IMPORTANT SAFETY NOTICE

PRODUCT AFFECTED: **Type G105, G106 & G107 Back Check Valves
Shipped During August, September & October, 2001**

**INCORRECT ASSEMBLY
 G105, G106 OR G107
 BACK CHECK VALVE**

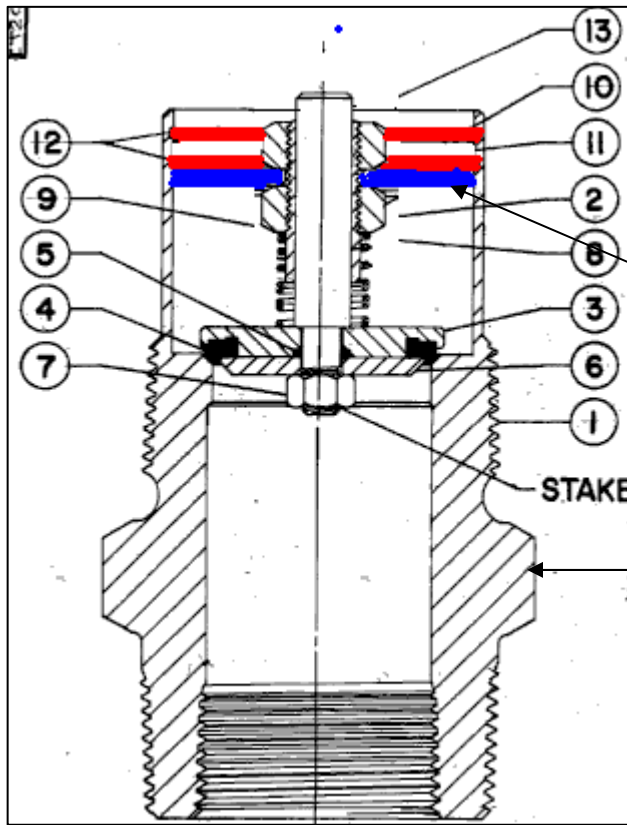
PROBLEM: Fisher Controls found an assembly problem with the G105, G106 and G107 steel Back Check Valves which could hinder the guiding and prevent the proper seating of the disc. **This improper seating is a potential safety problem, which could cause a fire and/or explosion resulting in property damage or personal injury if there were a hose or piping failure that required the back check to shutoff the flow of product.**

Guide (11) installed below lower retaining ring (12). Guide (11) should be installed between retaining rings (12)

- (1) **Check your inventory** of G105, G106, and G107 Back Check Valves for manufacturing stamped dates of 8-01, 9-01 or 10-01, or that have their box labels dated in August, September or October 2001.
- (2) **Return for replacement any inventory** that is found with these manufacturing dates to your Fisher Distributor.
- (3) **Locate any product that is installed.** Contact your Fisher Distributor to work out the details to replace the installed valve.
